RESPONSES TO  
NRC QUESTION  
ON THE  
DUANE ARNOLD ENERGY CENTER  
PUAR

PREPARED BY  
NUTECH ENGINEERS, INC.  
SAN JOSE, CALIFORNIA

PREPARED FOR  
IOWA ELECTRIC LIGHT AND POWER CO.

NRC QUESTION ON DUANE ARNOLD ENERGY CENTER

Figure 12 - 4"φ

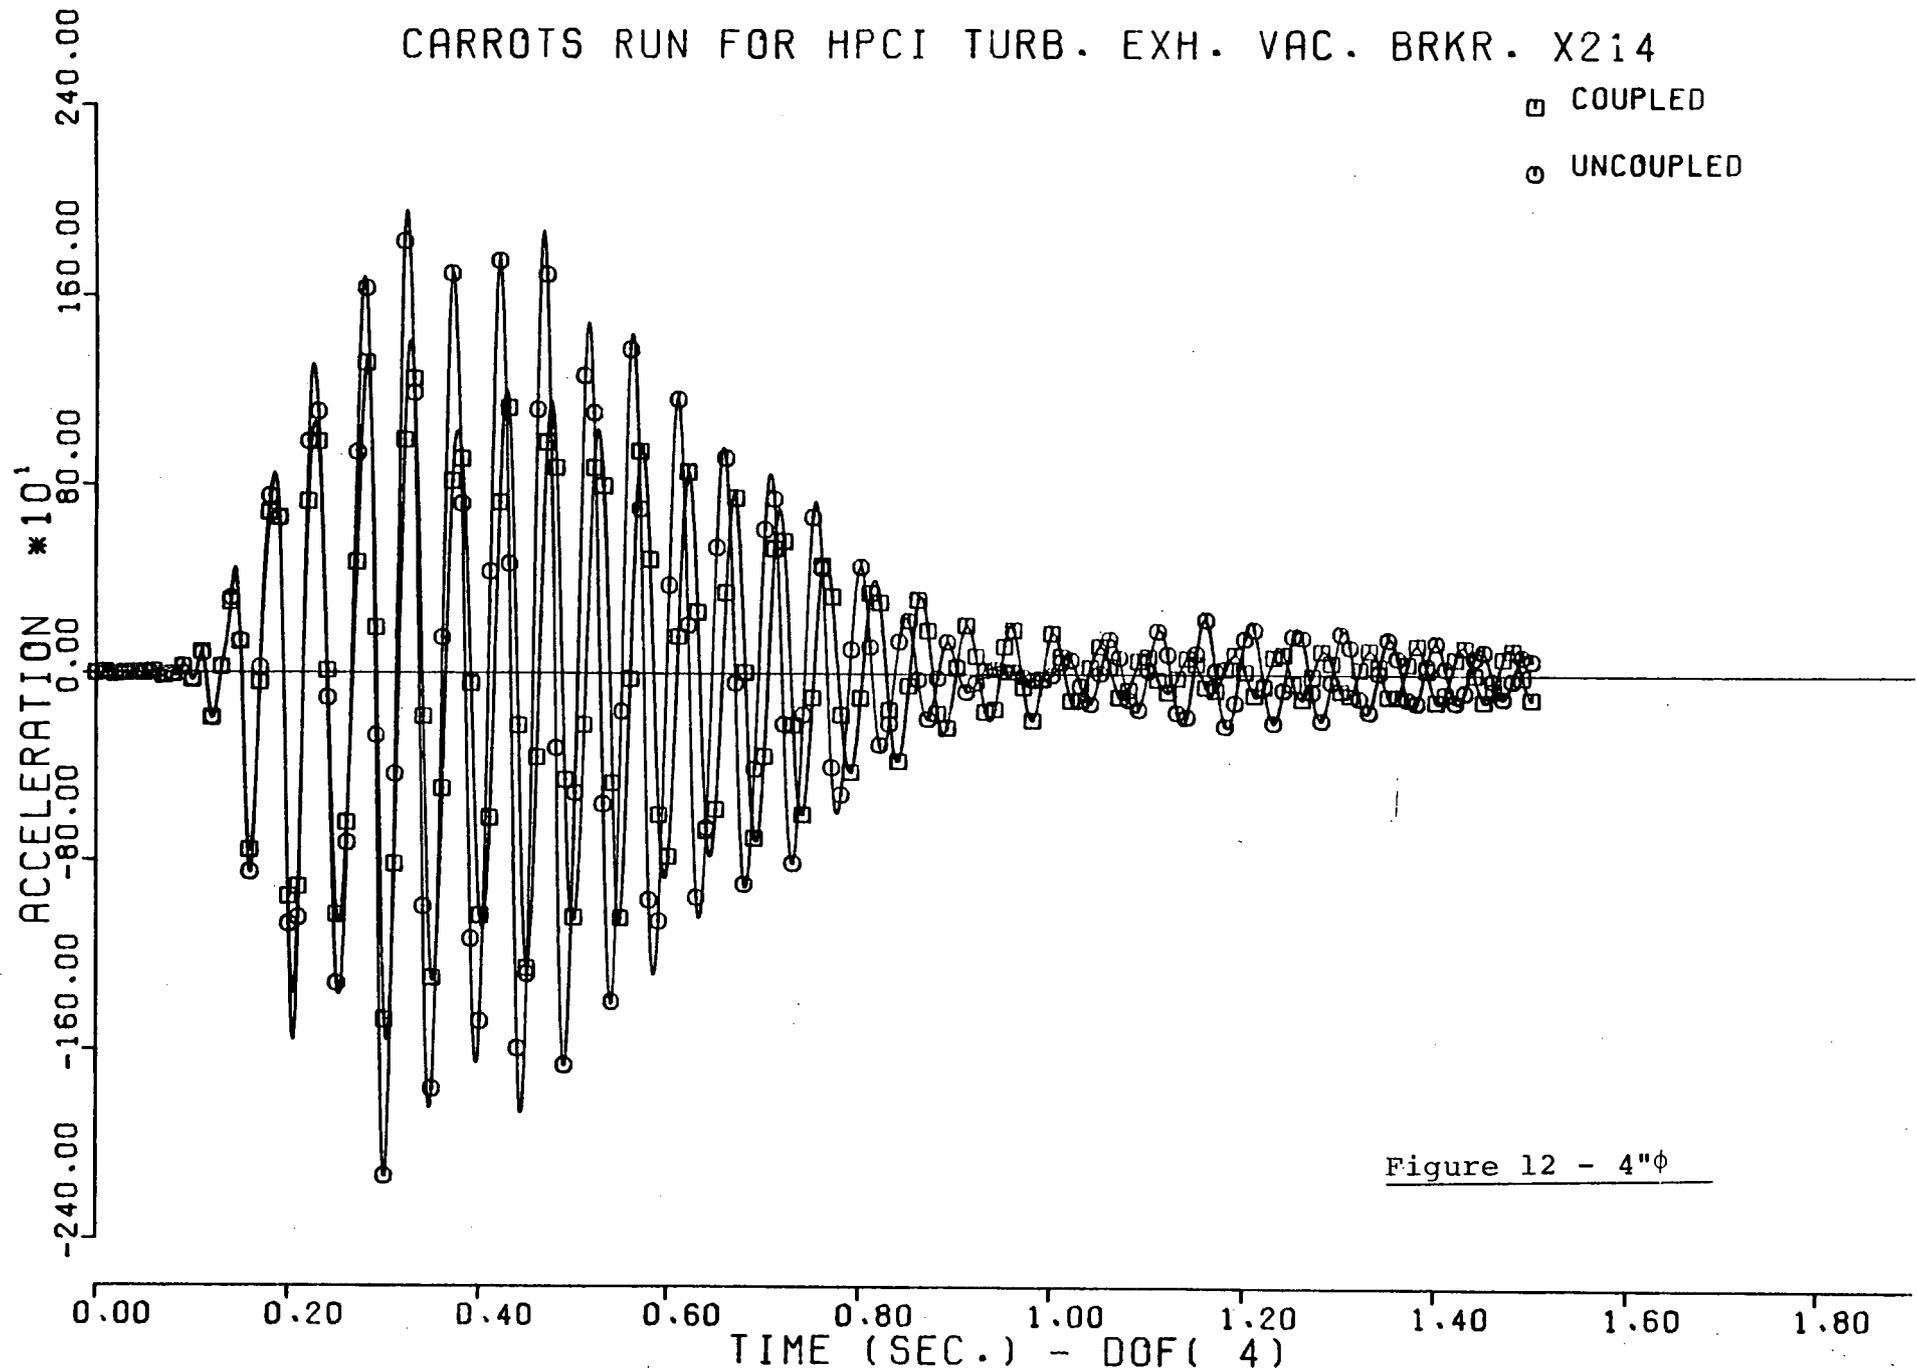
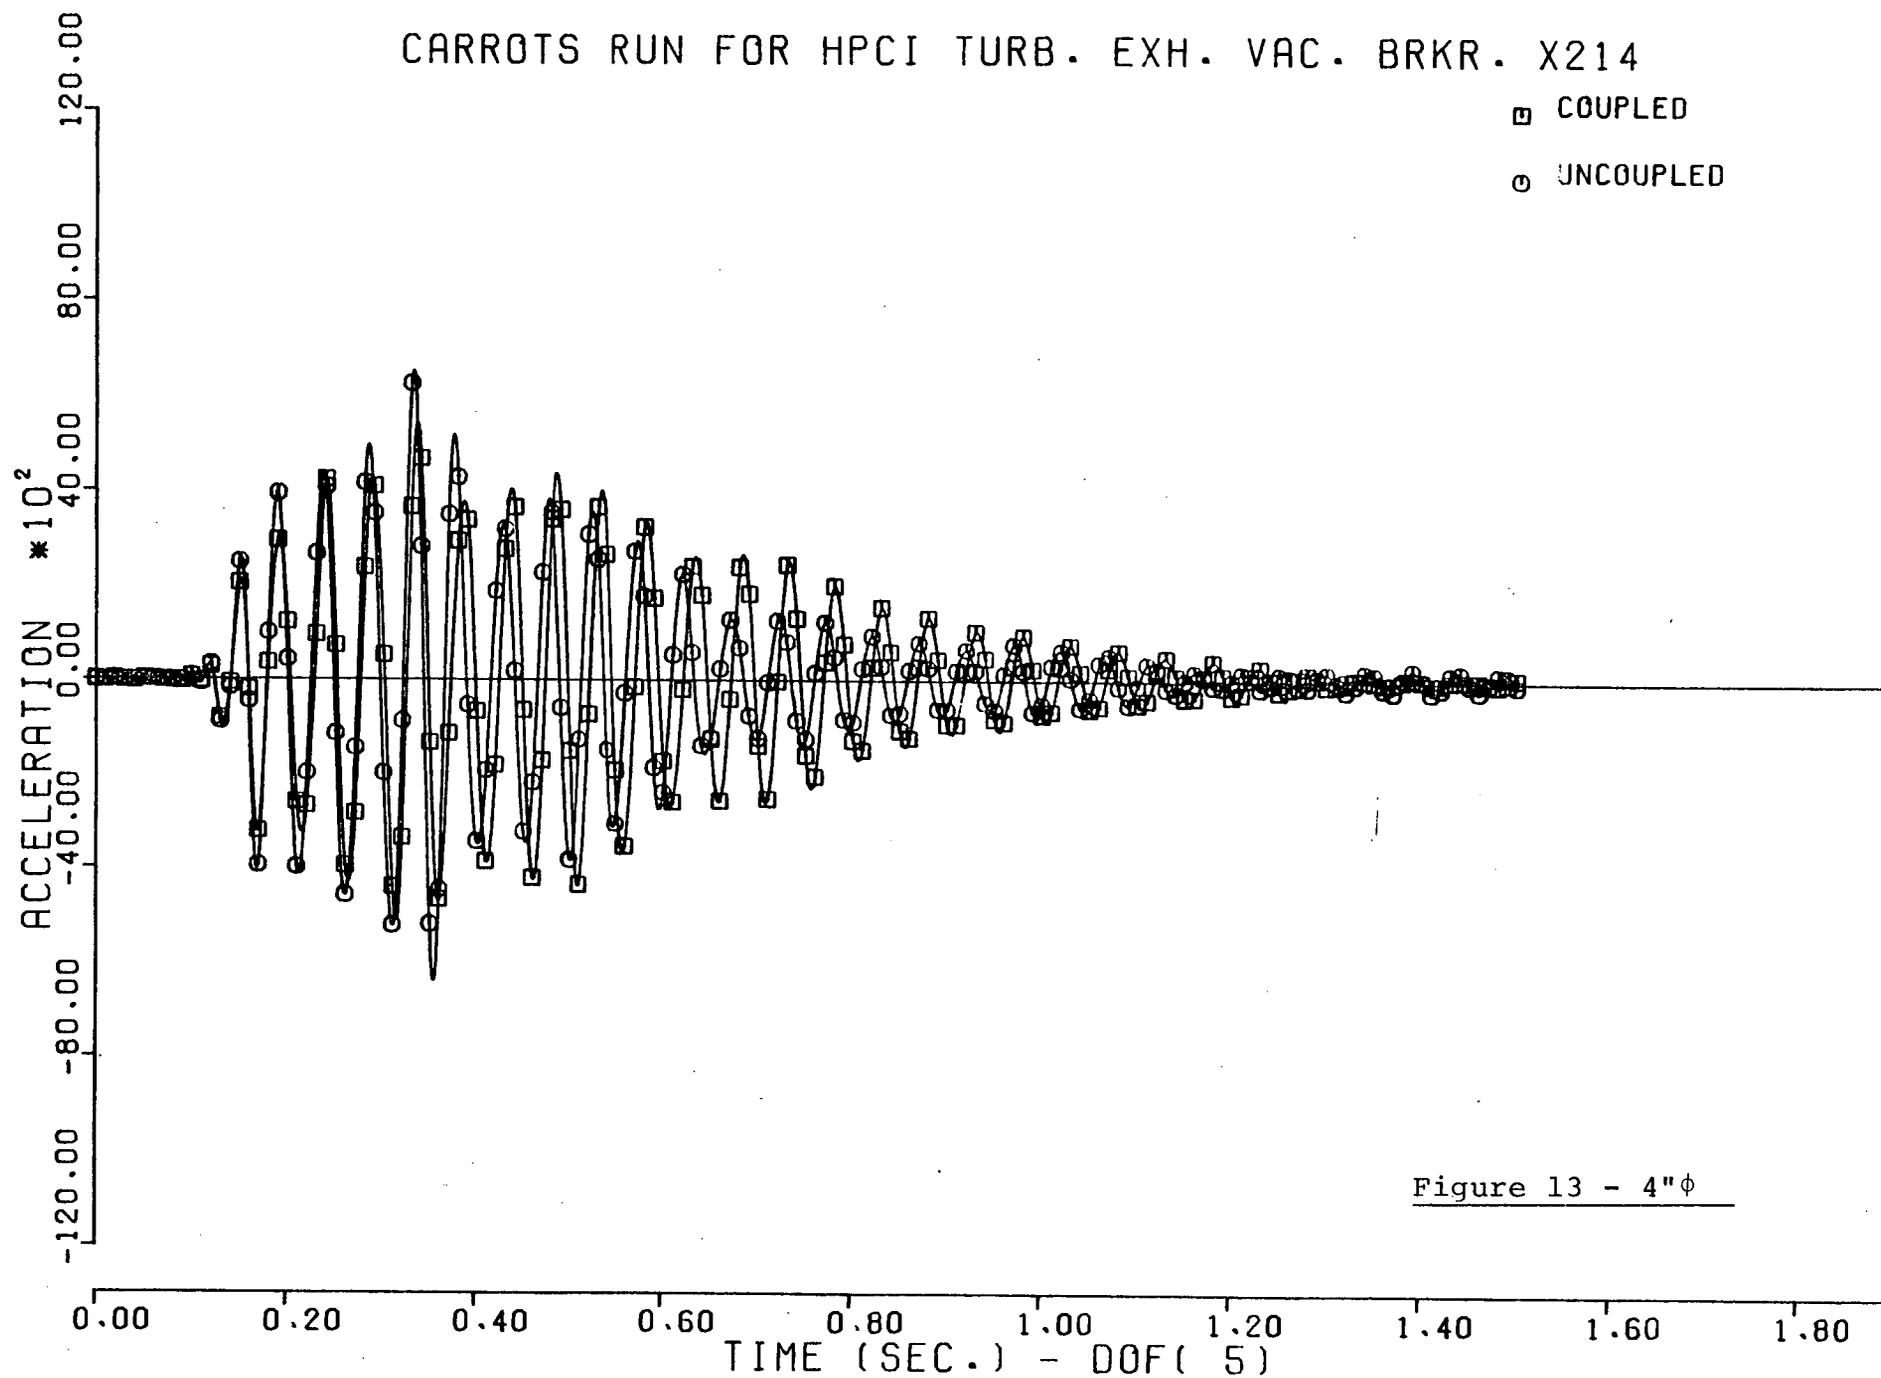
ITEM 3a: Provide the theoretical background in support of Section 2 of the report, and describe how the Section 6 guidelines (i.e., cut-off frequency and equations 2.27 and 2.28) have been used in the analysis.

To illustrate the effect of pipe size on coupling, four typical piping systems were examined and the coupled and uncoupled time histories plotted together. These time histories include both the smallest (2") and larger (20") systems analyzed. Listed below are the figure numbers and the corresponding line size.

Figure 4-8	2" diameter
9-13	4" diameter
14-18	6" diameter
19-21	20" diameter

These plots confirm the expected variation of coupling benefit with pipe size.
